**RELEVANT REPRESENTATION ON THE PROPOSED MORGAN AND MORECAMBE OFFSHORE
WIND FARMS TRANSMISSION ASSETS DCO**

PLANNING INSPECTORATE REFERENCE NUMBER: EN020032

Figure 1

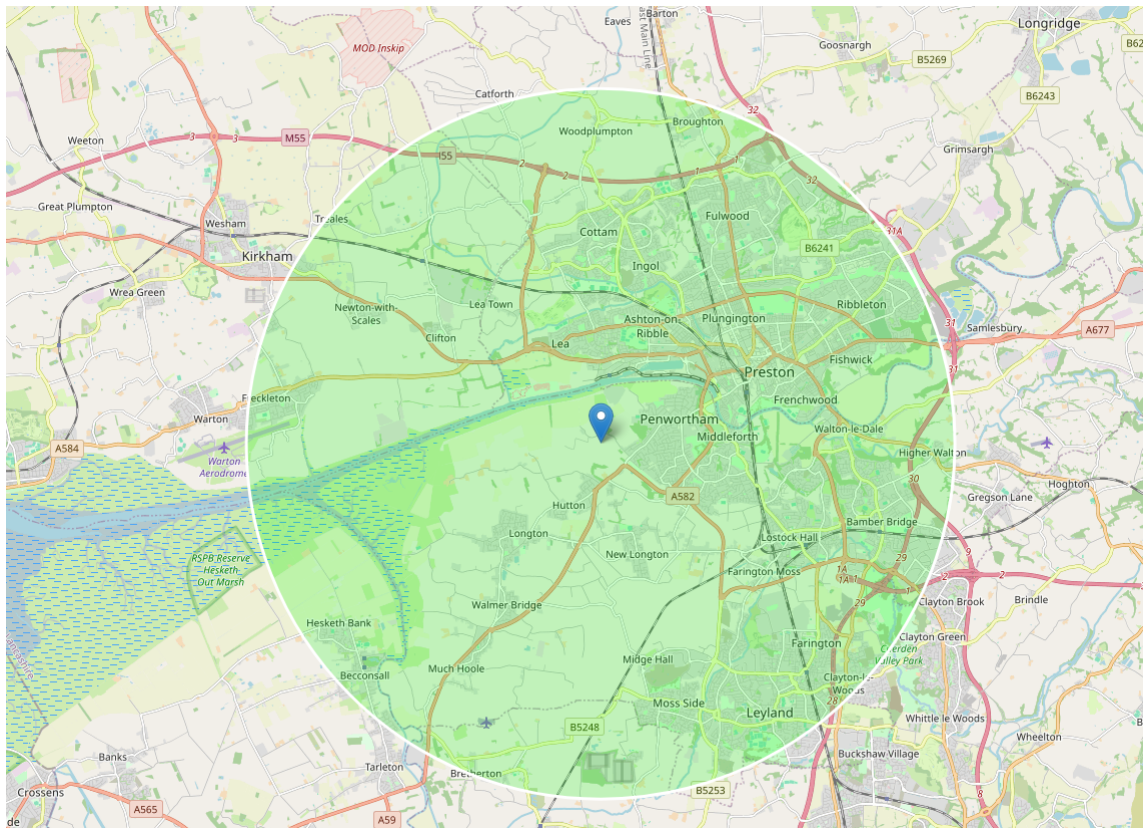
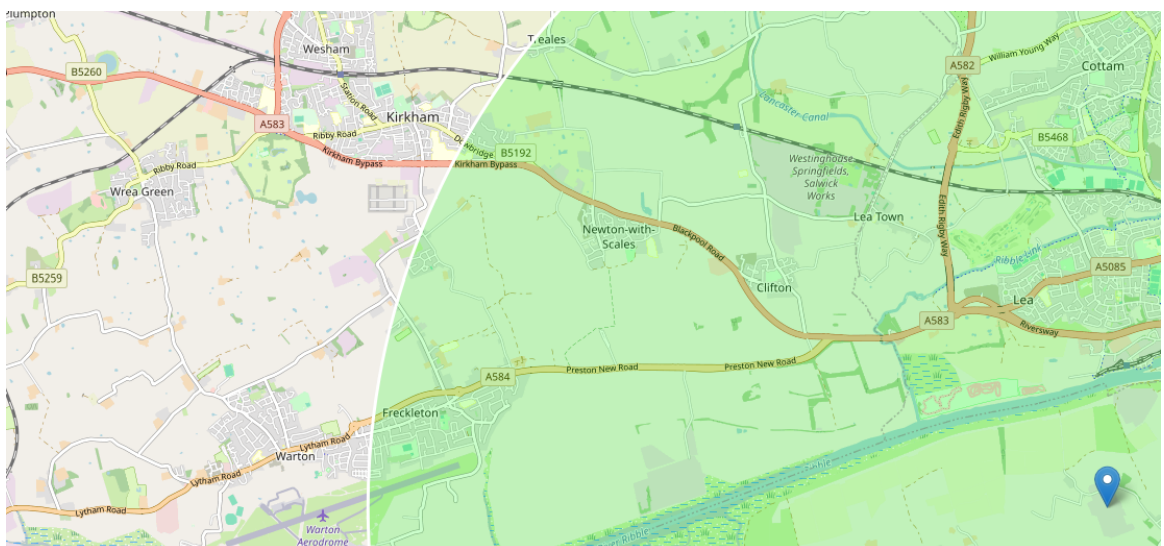
- 1.6 It is unclear why both substations could not be combined into a single site, where reasonable separation measures would ensure the independence of the Morgan and Morecambe lines. The placement of these substations in close proximity has the effect of doubling the environmental impacts. In addition, the choice of an 8 kilometre search zone for the placement of the substations is not explained, and the chosen site is situated at the very edge of this zone as shown in **Figure 1** and **Figure 2**. The [Moor Vannin Offshore Windfarm Project](#), a [NSIP connecting from the Isle of Man to the Penwortham substation](#) has not only demonstrated a search area (covering north to Fleetwood), but has also included the Hillhouse route (detailed in paragraphs 1.14 to 1.21 below) within its scope. If substations can be separated from the Penwortham substation, why couldn't they be further away? If distance has a greater impact due to a higher voltage cable between the substation and Penwortham, why was this not factored in to give greater weight to closer options rather than choosing a site at the limit of the chosen search area.
